# TECHNICAL SERVICE BULLETIN

Bulletin Number: Z-16-01-AA

**SUBJECT: 2014-2016 RZR XP / XP 4 1000 and 2015-2016 RZR 900 / S 1000  
FUEL TANK VENT LINE REPLACEMENT**

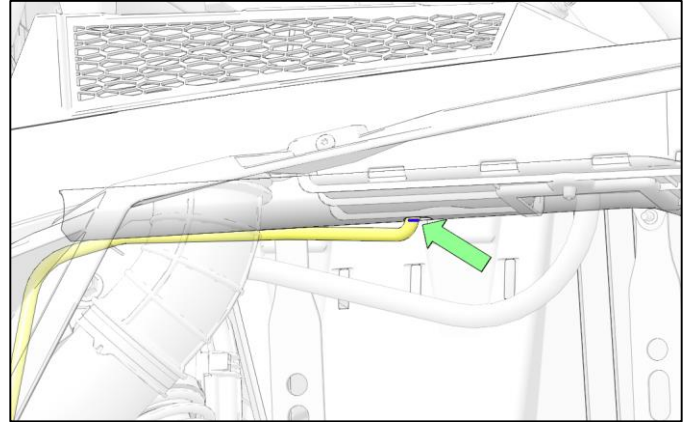
1. Loosen the fuel cap.
2. Mark the fuel tank vent line to determine original depth into frame.
  - 2014 and 2015 (early build) RZR XP 1000 / XP4 1000 – on cross member frame rail behind the airbox.
  - 2015 (late build) RZR XP 1000 / XP4 1000 – on the rear upper frame rail above the PVT

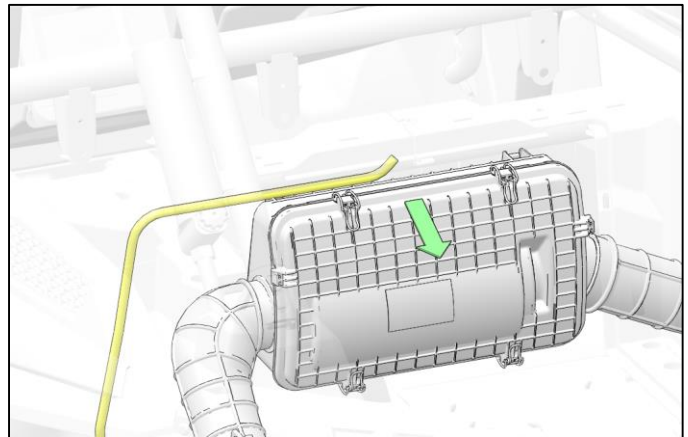
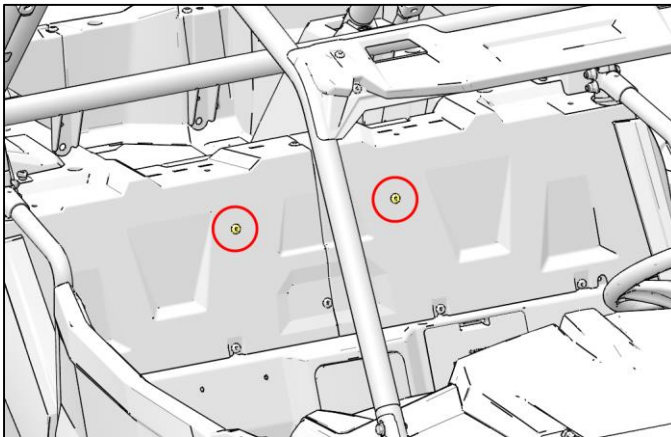
**NOTE:** For 2014 and early build 2015 RZR 1000 models ONLY, remove the seats (rear seats for XP4 models) and two bolts (circled in red) retaining the upper air box and carefully pull the air box towards the rear of the vehicle for improved access to the vent line.

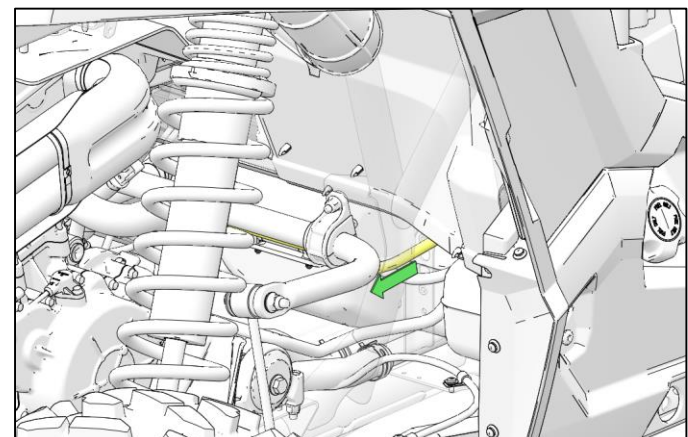
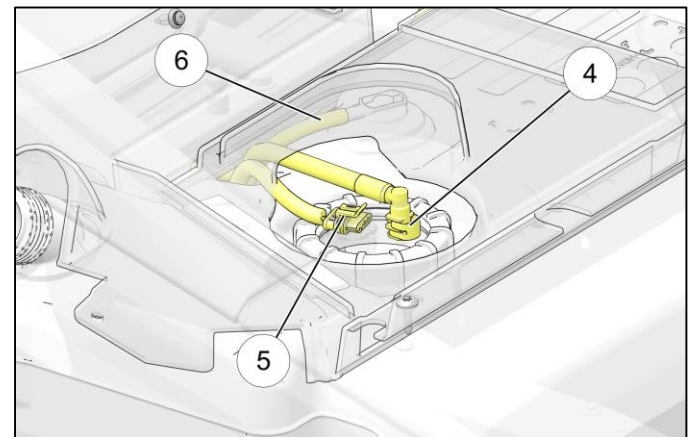
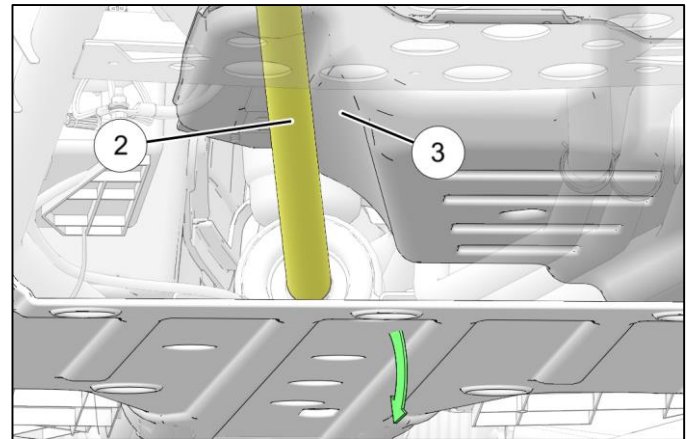
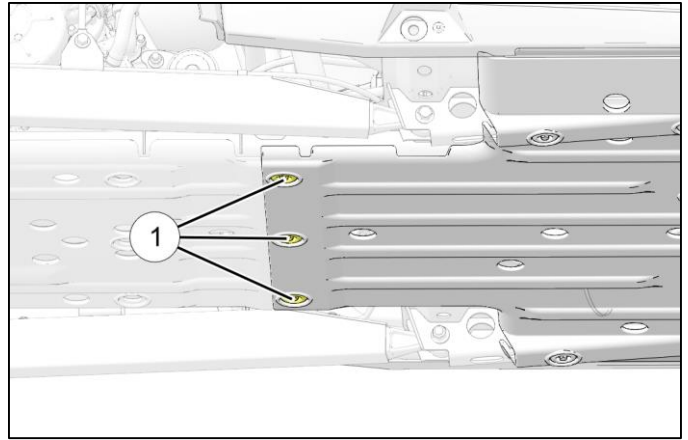
6. Remove the three rear skid plate fasteners ① to gain access to the prop shaft and fuel tank.
7. Inspect for damage due to the prop shaft ② rubbing into the fuel tank ③. *If there is damage from the prop shaft, take photos of the damaged vent line, the wear on the prop shaft, and the damage to the fuel tank. Start an Ask Polaris → Service and Warranty Question → Authorization: Non-Cosmetic & Polaris ESC case. Attach the photos to the case and for the CONCERN, CAUSE and CORRECTION enter "SB Z-16-01-AA". Use part number 2521436 as the primary failed part, enter the appropriate flat rate time, and submit the case to Polaris. You will still need to file the service bulletin claim once completed.* Continue to step 8.

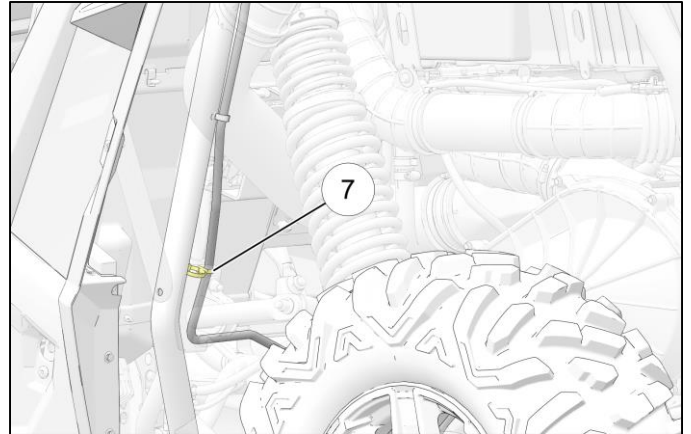
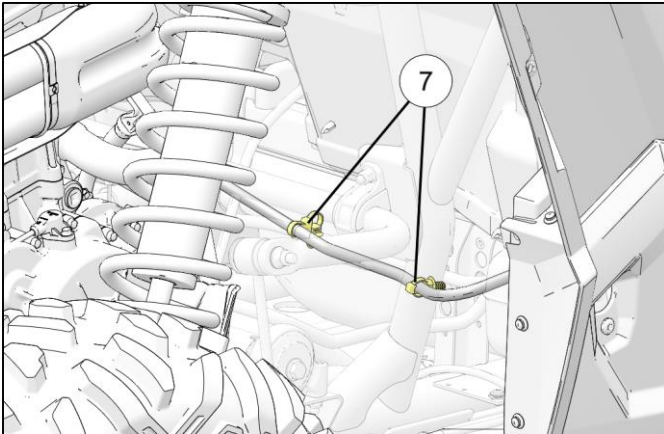
13. Slide the original vent line out of the zip ties (7) retaining the vent line and slide the new line through the zip ties.

**NOTE:** The vent hose fits loosely in the zip ties so they shouldn't need to be cut.

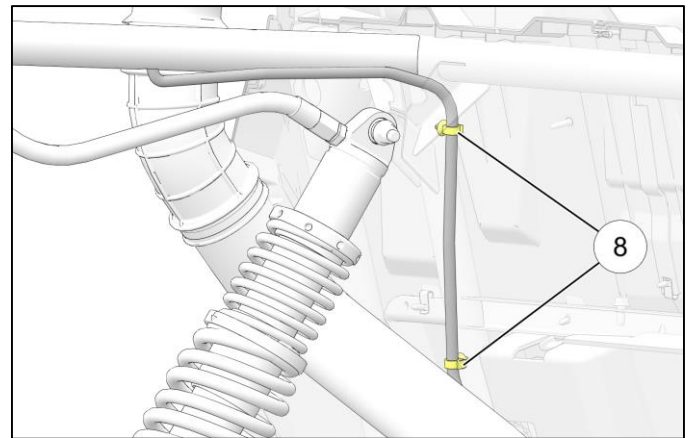
14. Open the line clips (8), located on the frame upright for the driver's side rear shock, and remove the vent line and install the new vent line and refasten the clips.

15. Using the original vent line routing as a guide, route the new vent line through the upper shock mount area. Use caution to avoid kinking the vent line during installation.

16. Install the new vent line onto the fuel tank fitting.

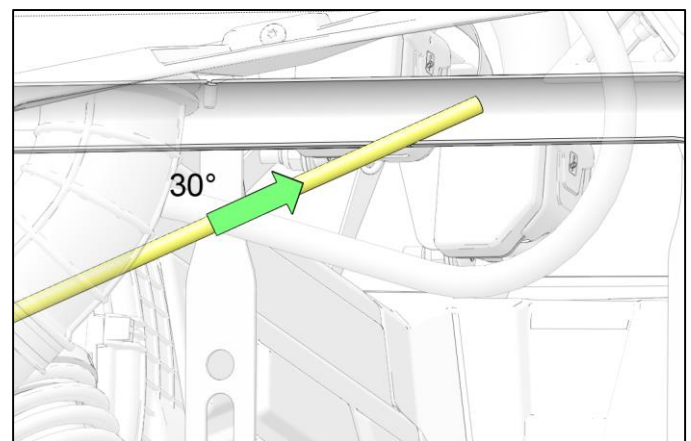
18. Using the old vent line as a reference, put a mark on the new vent line to indicate the depth the hose should go into the frame.
